City of Jacksonville, Florida

CITY OF JACKSONVILLE
DEPARTMENT OF PUBLIC WORKS
ENGINEERING DIVISION
CONSTRUCTION CHANGE ORDER

Change Order No. Three (3) Date April 22/2026

Description of Project Emerald Trail Model Project Construction

Project Title :	*PCO# 029 Vehicle Detection System*
Proj.-	*Emerald Trail Model Mile Project*	Extended/Added By:	*Het T*
Loc.-	*Jacksonville, FL*	Checked By:	*Het T*
A/E -	*Pond*	Priced By:	*Het T*

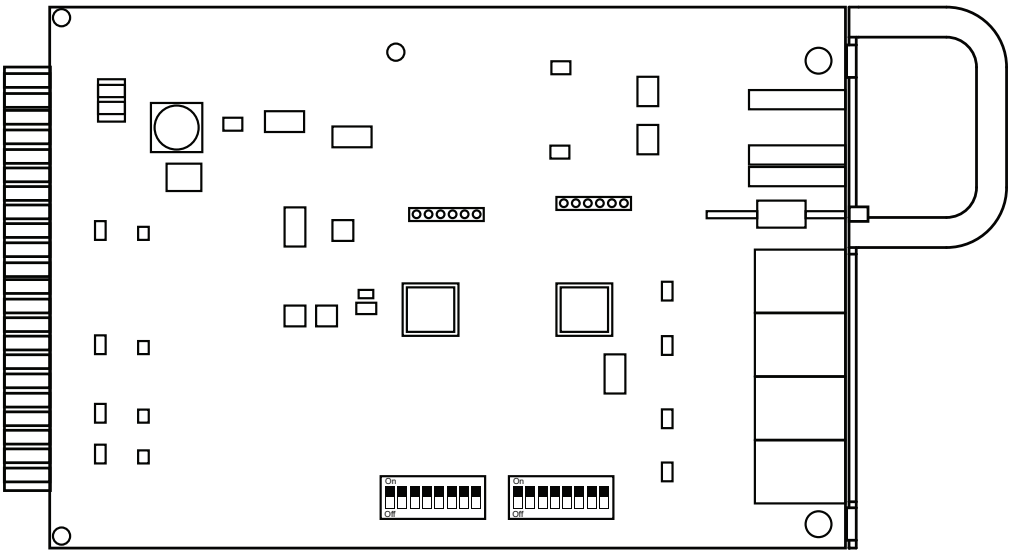
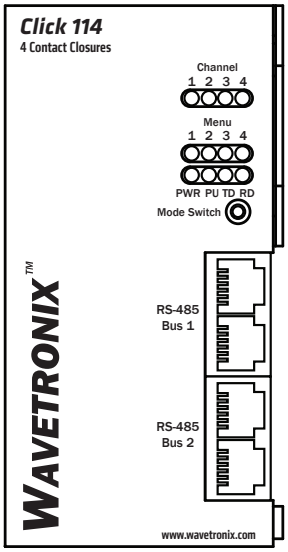
NBR	MASTER ITEM DESCRIPTION	QUANTITY	UOM	UNIT COST	NET ADDITION	NET DELETION	TOTALS
	ADDED/DELETED SCOPE OF WORK						
1	PCO#029 VEHICLE DETECTION SYSTEM	1.000	LS	$15,886.81	$15,886.81		**$15,886.81**
	JUSTIFICATION: The existing signal control cabinets along Lee St at multiple intersections could not support the new vehicle detection devices required for the project. The solution is to install an intermediate component in the existing cabinet to allow the vehicle detection devices to work properly. This includes, labor, materials, and equipment to install these components.						
2	DELETE SHADE STRUCTURE AND RELATED COMPONENTS						
	Bid Item #187-Shade Structure Connecting Bracket	-2.000	EA	$5,247.32		($10,494.64)	**($10,494.64)**
	Bid Item #188-Shade Structure (Custom Fabrication)	-1.000	EA	$414,129.56		($414,129.56)	**($414,129.56)**
	Bid Item #189-Custom Parasoleil Shade Structure Skin, Botanical	-78.000	SF	$31.48		($2,455.44)	**($2,455.44)**
